OVERLOT GRADING, POND SR4 & UTILITY CONSTRUCTION DOCUMENTS

FALCON MARKETPLACE

REVISED SHEETS C7.1-C7.5
8-31-20

Approved with conditions as noted above**
by Elizabeth Niekamp
El Paso County Planning and Community Development
on behalf of Jennifer Irvine, County Engineer, ECM Administrator
10/10/2018 3:30:30 PM

**SUB-REGIONAL
 POND #1 (SR4)**
 PROJECT NO. 20988-00CSV
 DRAWING NO.

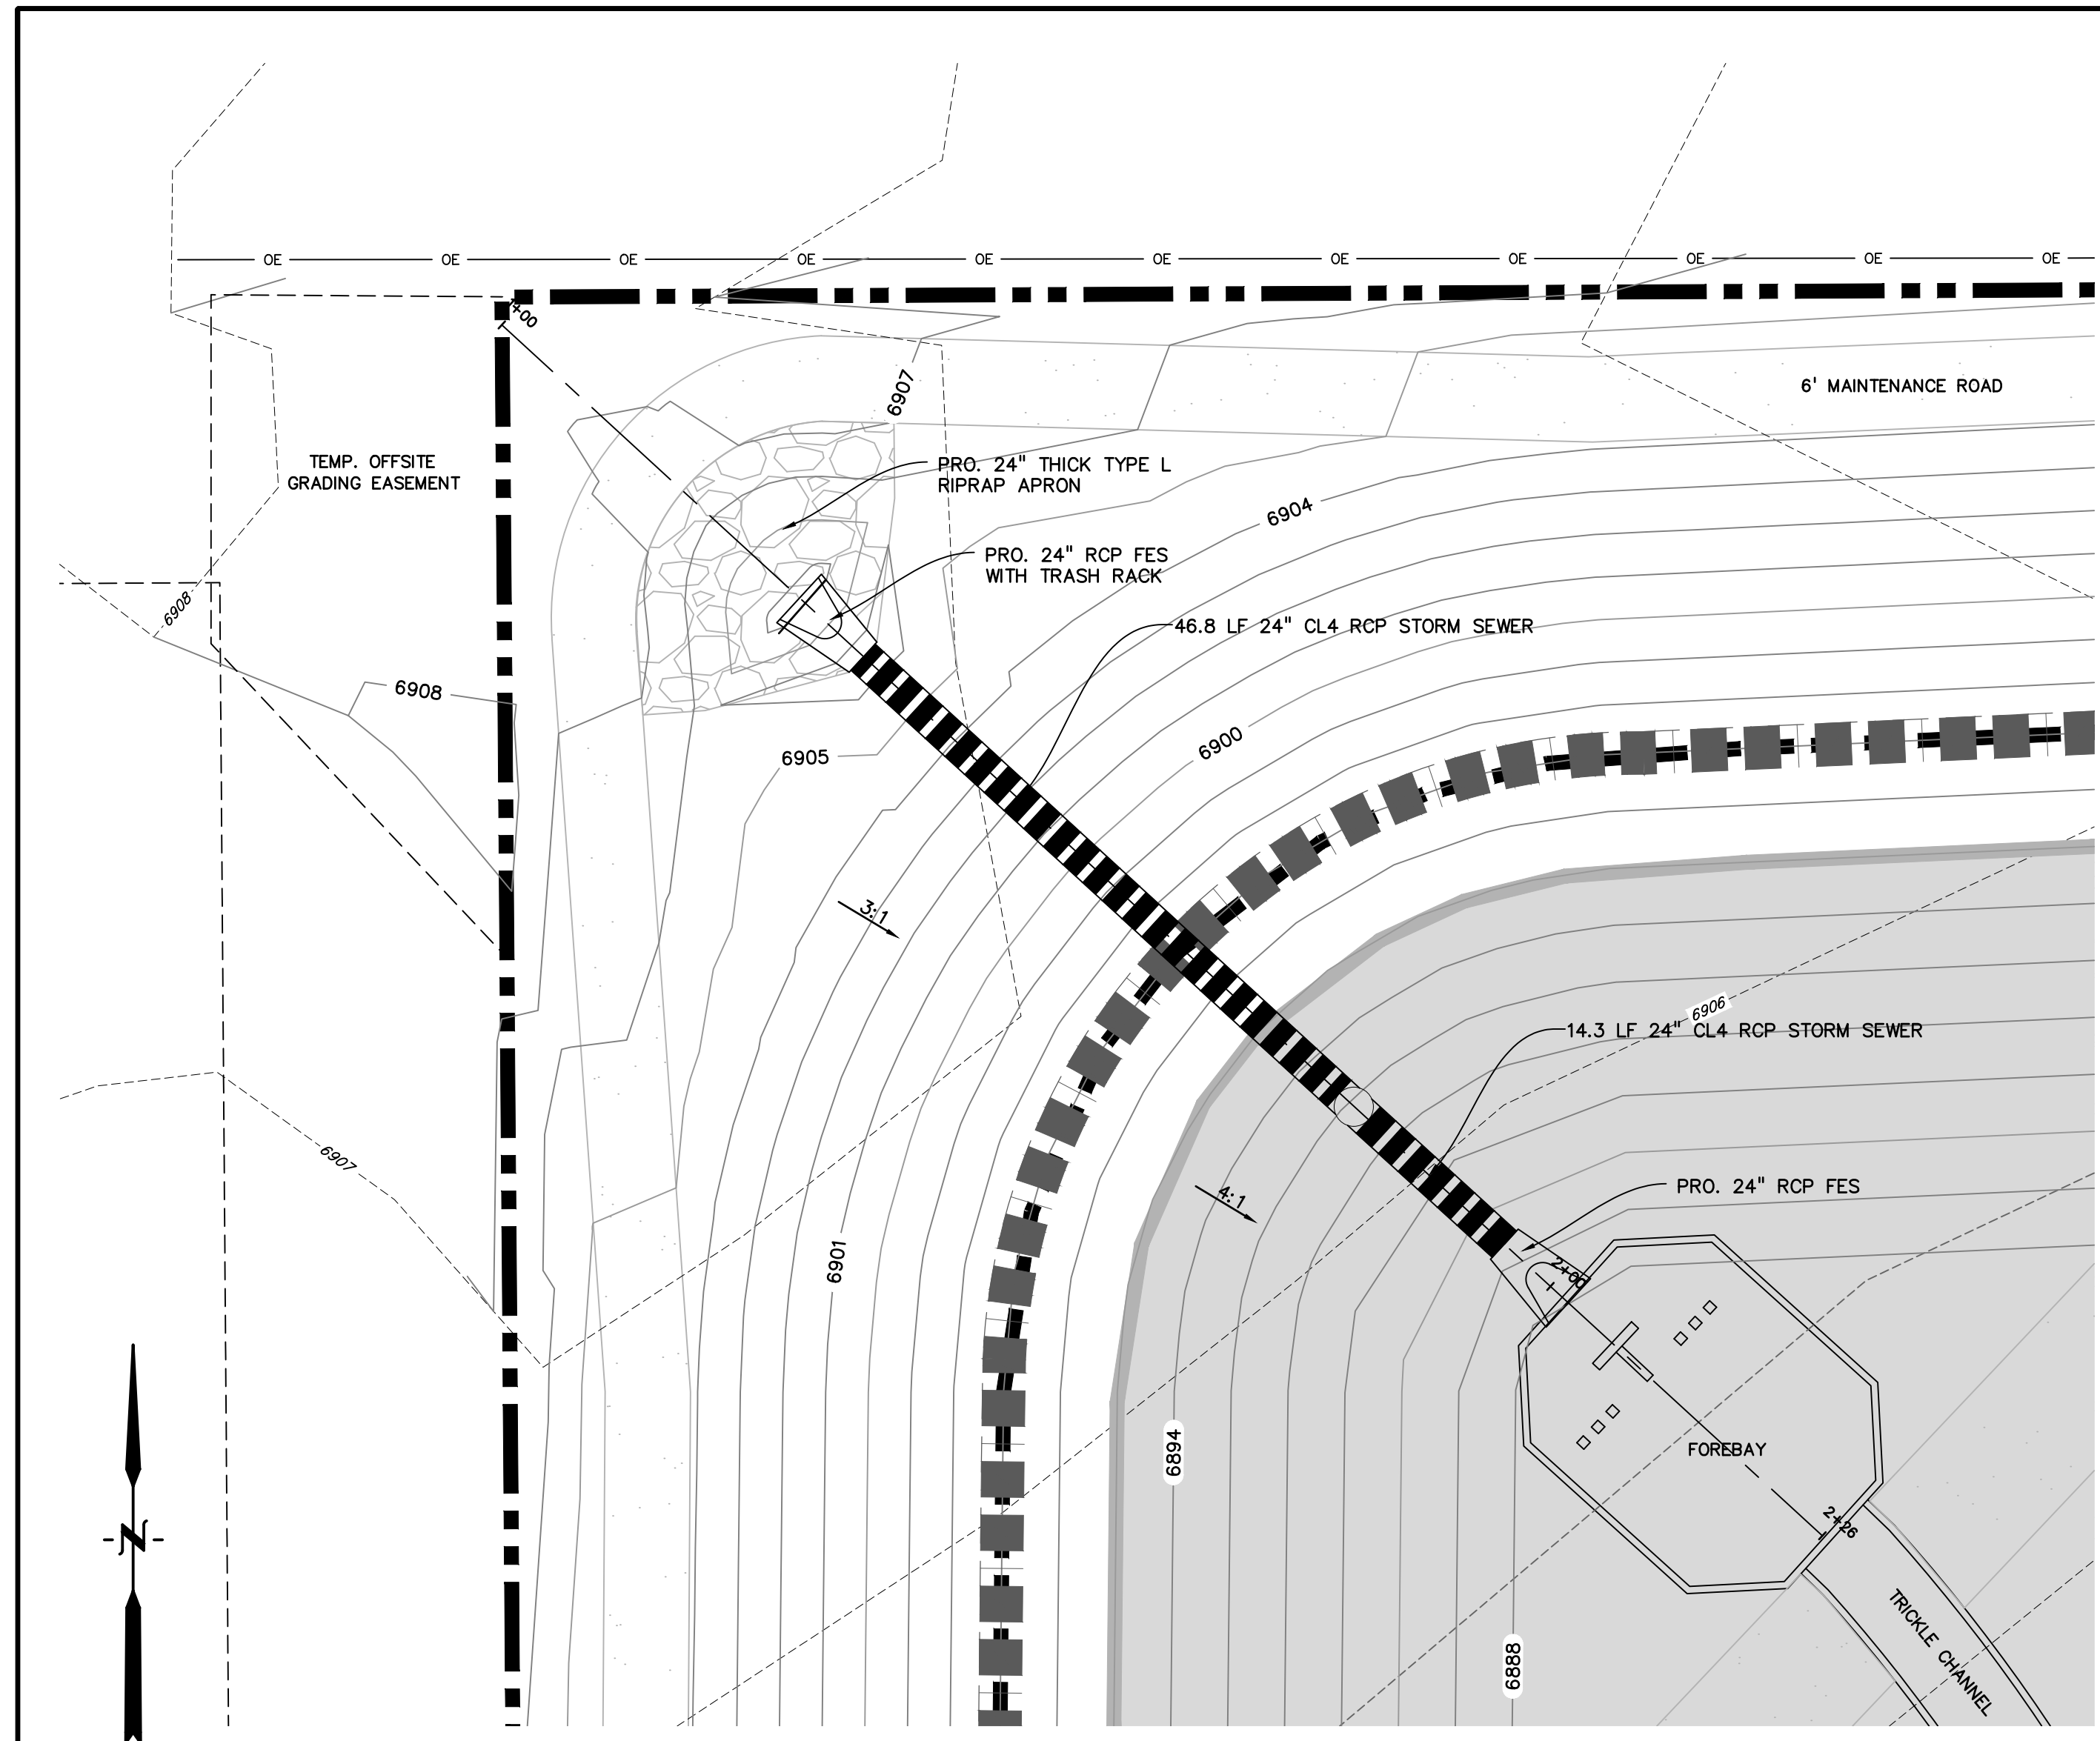
- The clay liner proposed for Pond SR4 construction is not approved at this time. Provide rationale that other impermeable lining methods are not practicable, including rubber lining. Placement of any liner requires separate written approval after PCD staff receipt of this additional information as well as project-specific liner specifications, signed and stamped by a Colorado PE.

- The riprap spillways proposed for Pond SR4 construction are not approved at this time. Provide an analysis for the use of riprap, geocellular products and articulated concrete block products. Written notification from PCD staff is required prior to installation of the spillway protection.

- Outlet structure construction requires separate written notification from PCD staff. Additional information regarding outlet grate/trash rack design is required for verification of velocities.

- Additional information is required on how groundwater will be handled during pond construction. Provide additional geotechnical study/potholing information on groundwater levels and the geotechnical engineer's concurrence with these CDs when available.

NORTHWEST DRAIN PLAN
1"=10'

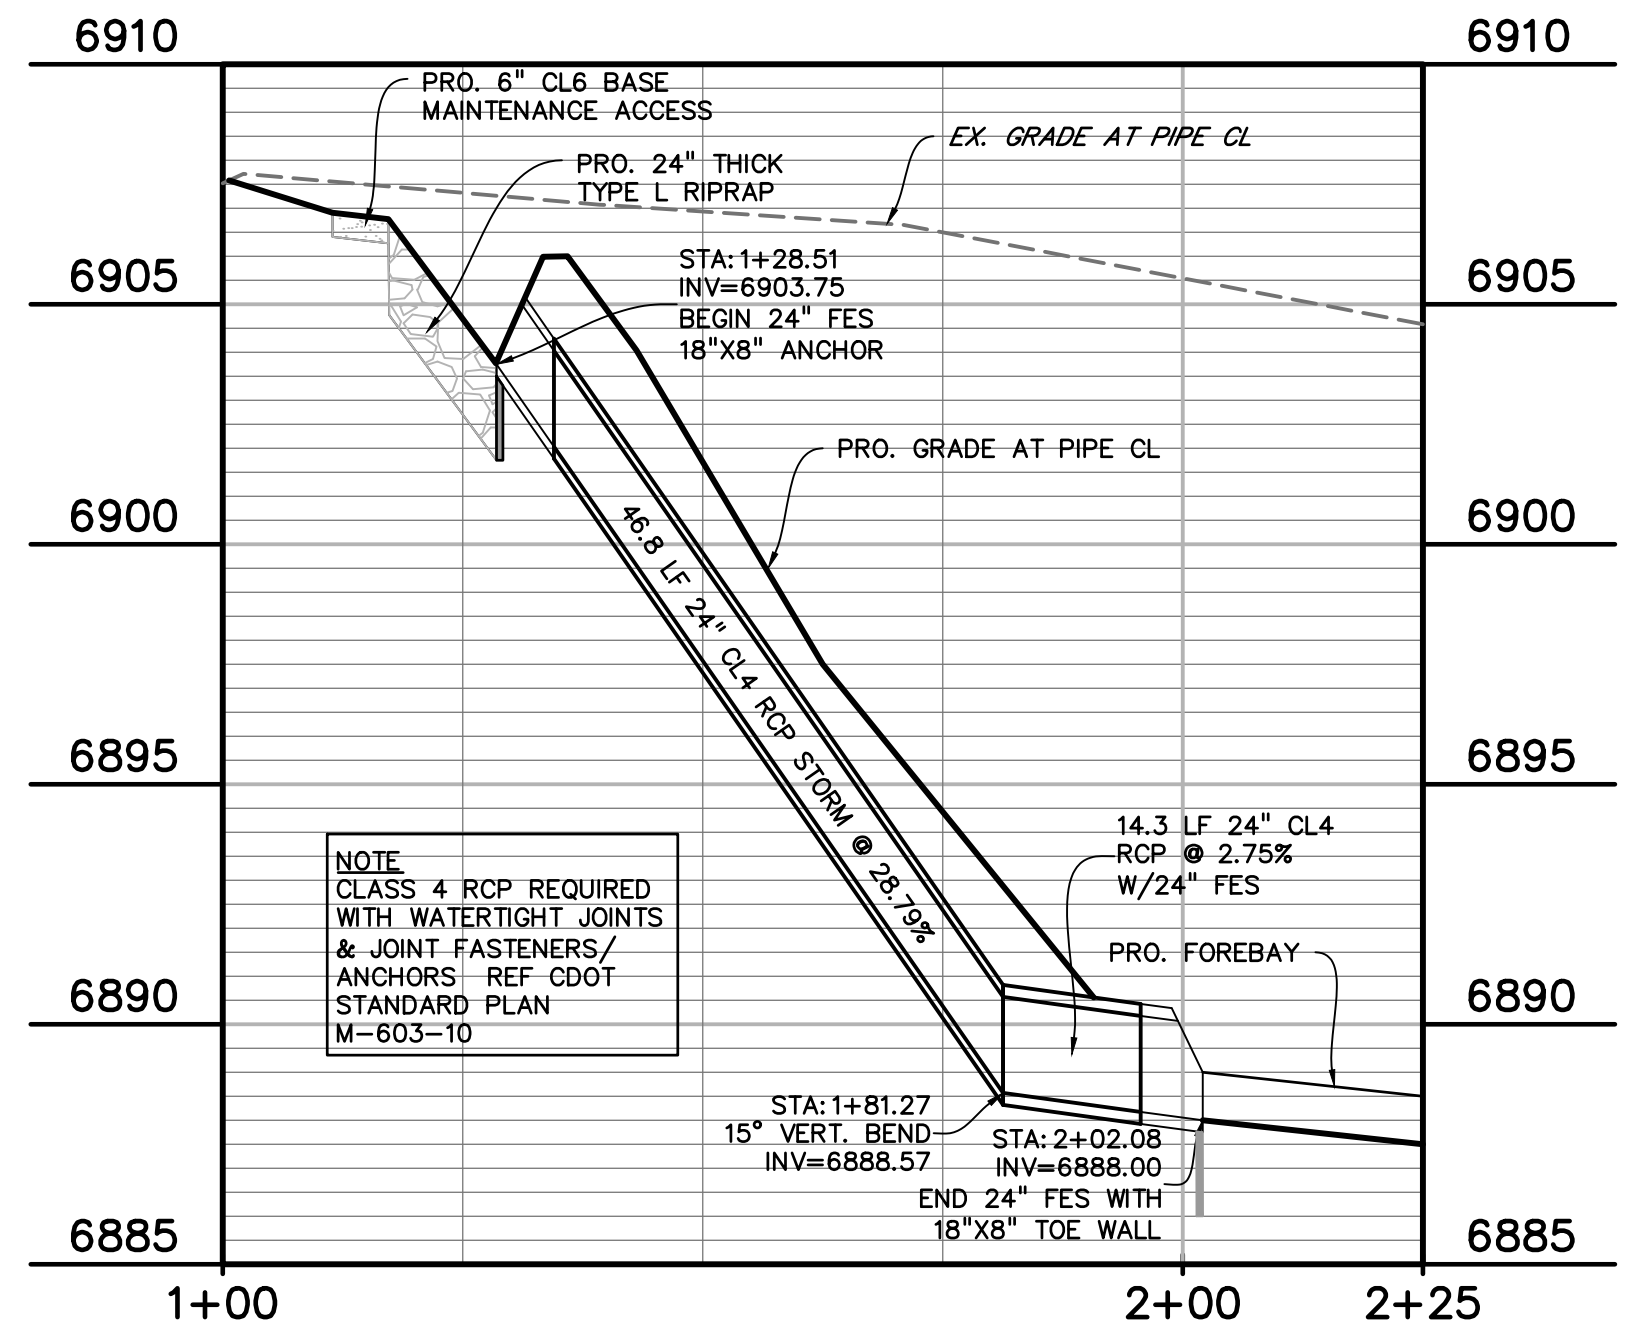
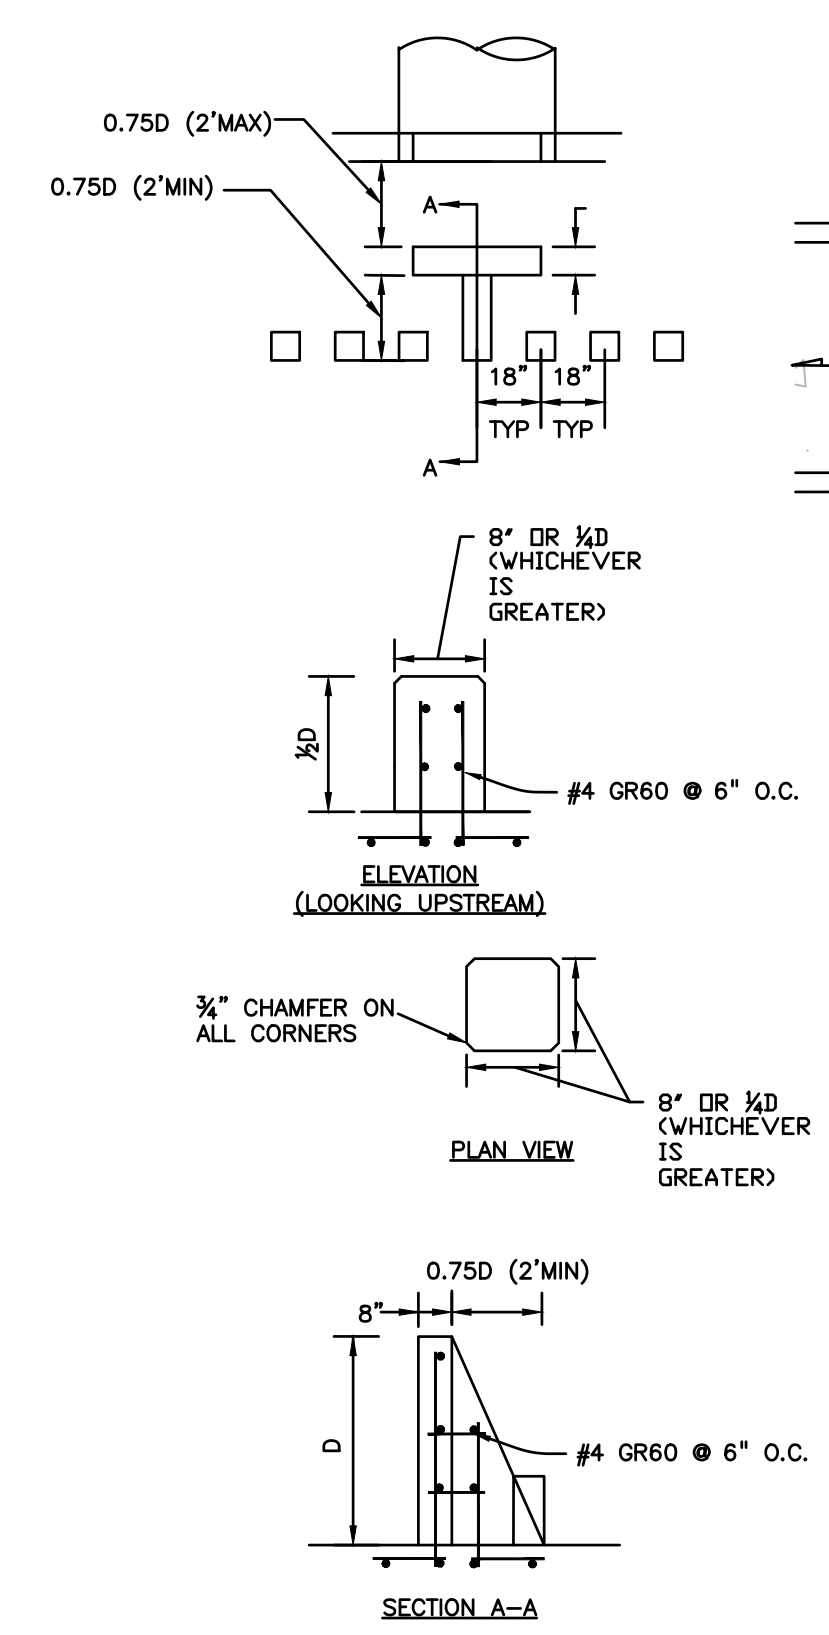
- Additional requirements for the inflow pipe from the northwest (class of pipe, anchoring/support, and watertight joints) may apply. Construction of this pipe and appurtenant items shall not begin without written County approval.
